## **ITEM # 6.0**

### **PRELIMINARY & FINAL PLAT APPROVAL:**

Sendero Phase IA Subdivision  
Being a resubdivision of 16.473-acres of land out of  
the south end of Porcion 52  
PUD (R-1)  
Developer: Rhodes Development, Inc.  
Engineer: Melden & Hunt, Inc.

### **REVIEW DATA**

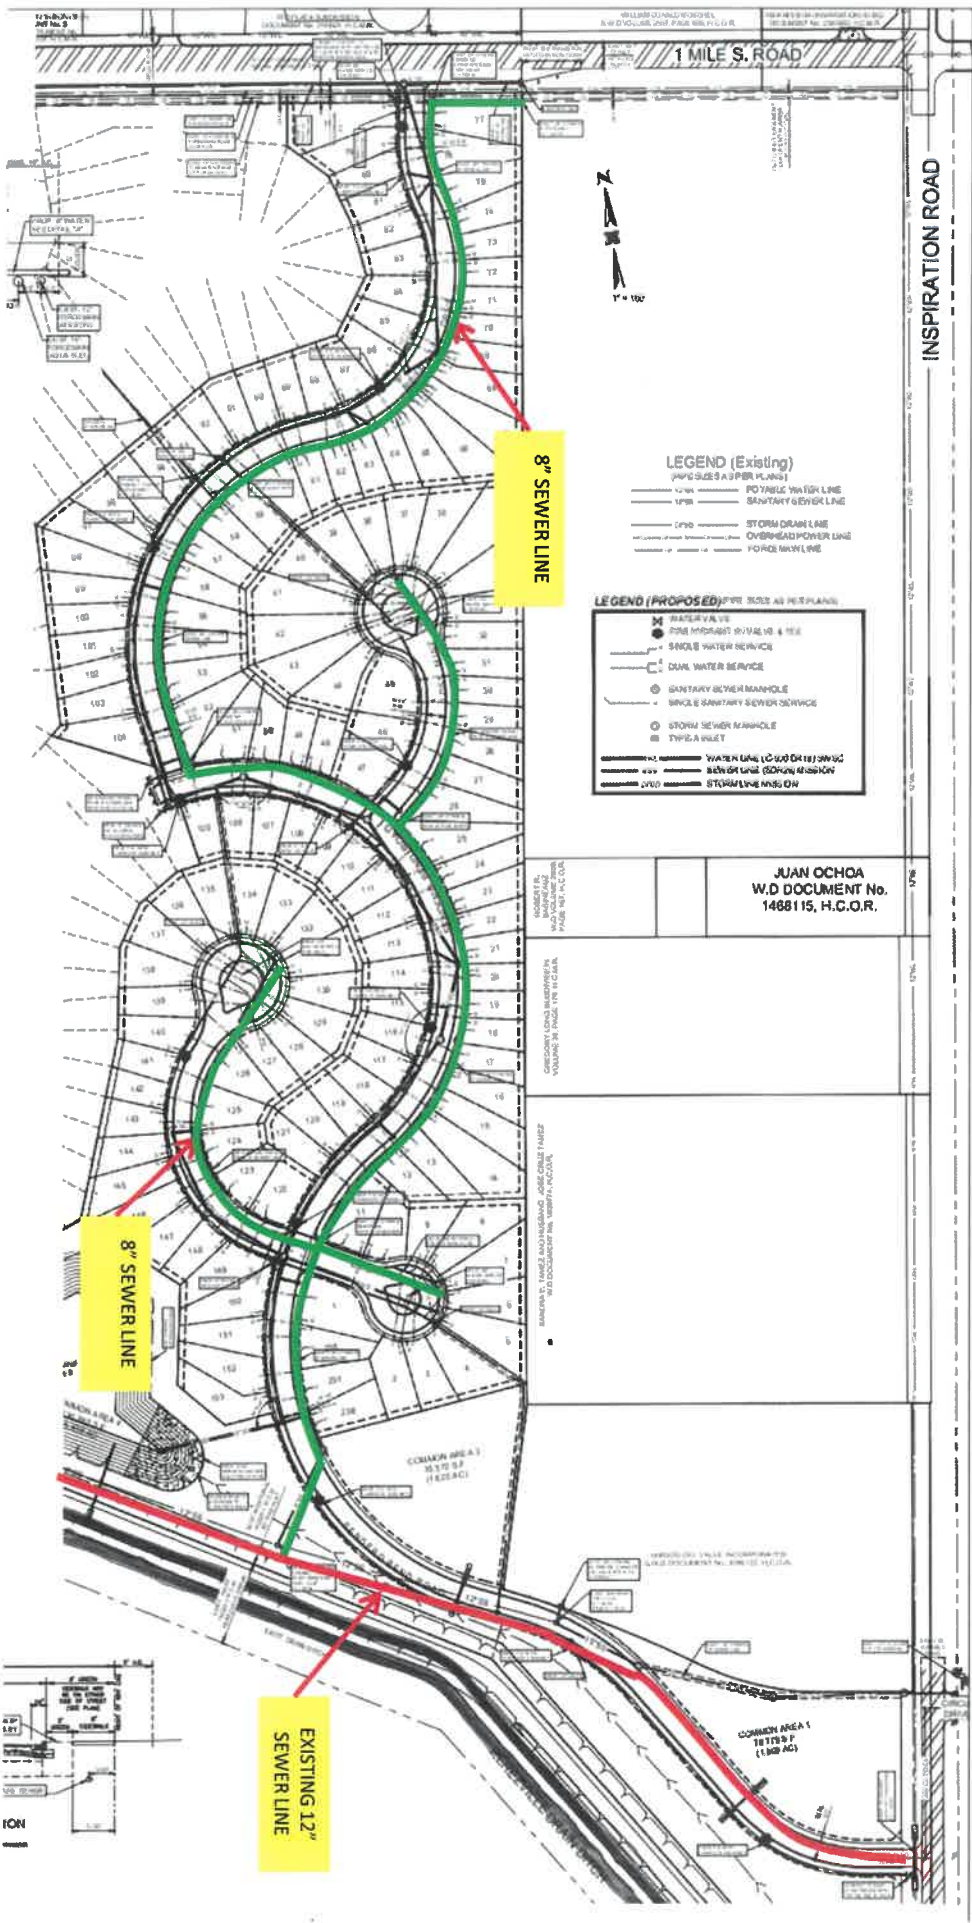
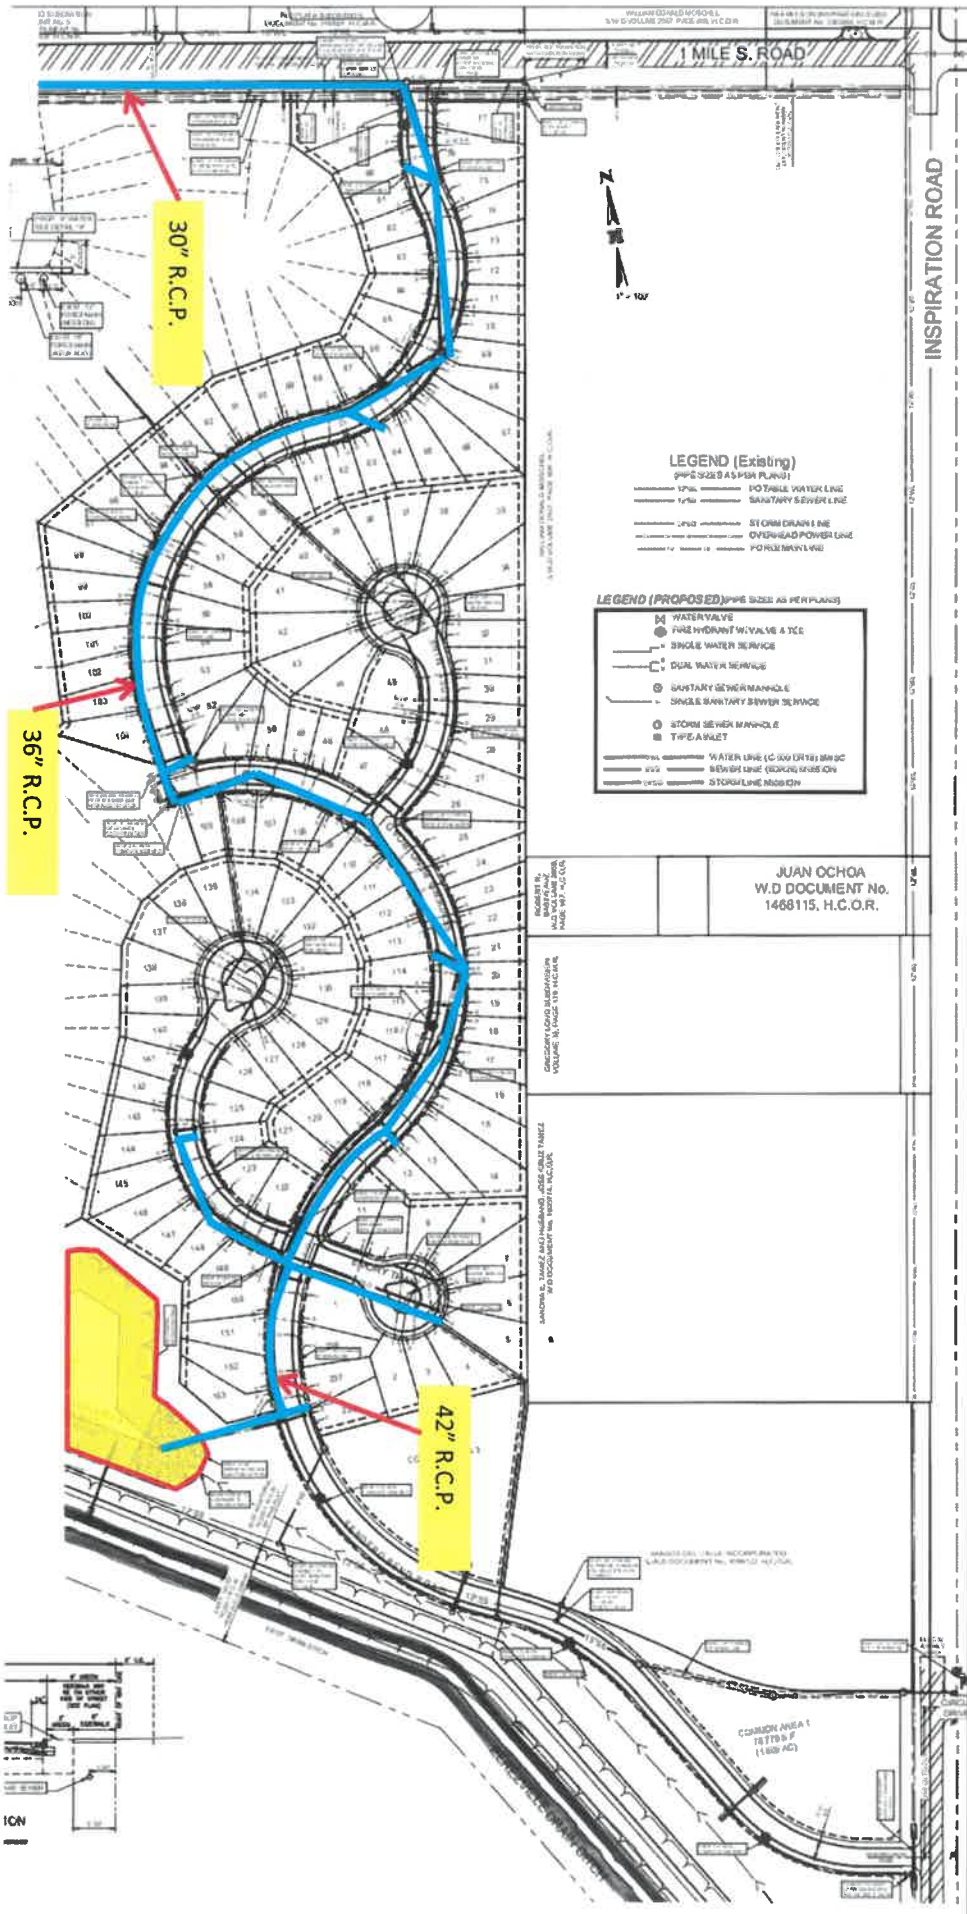
The developer connected to an existing 12" water line located along the south R.O.W. of Mile One South Rd. and extended an 8" water line through the subdivision providing a 2" water service to each lot. There are 5 fire hydrants via direction of the Fire Marshal's office. – see **utility plan**

The developer is proposing to connect to an existing manhole within the R.O.W. at the southern access of the development and extend a 12" line west along the north side of the Perezville Ditch. An 8" Sanitary Sewer line will run through the subdivision and collect from each lot through a 4" front and center stub out service. The Capital Sewer Recovery Fee are required at \$200.00/Lot which equates to \$22,200.00 (\$200 x 111 Lots).

The proposed internal street is a 32' Back-to-Back within a 50' Right of Way, access will be from Mile One South Rd. and/or Inspiration Rd. The storm drainage system will consist of multiple curb inlets ranging in size from 24" to 42" RCP. Surface and street runoff will be caught by said inlets and conveyed via storm lines into the Perezville Drain (owned by H.C.D.D. No. 1) adjacent to south side of this property and ultimately have an outfall into the Mission Pilot Channel system of the H.C.D.D No.1 via 5'x5' box culvert under the United Main Canal. The development is included in Drainage Basins 26 & 32 of the Bentsen Palms Master Drainage Study. The required detention of 278,000 cubic feet (6.336 ac-ft) shall be provided within the Perezville Drain Ditch widening. The City Engineer has reviewed and approved the drainage report.

1. Payment of Capital Sewer Recovery Fees
2. Provide Water District Exclusion
3. Comply with all other format findings
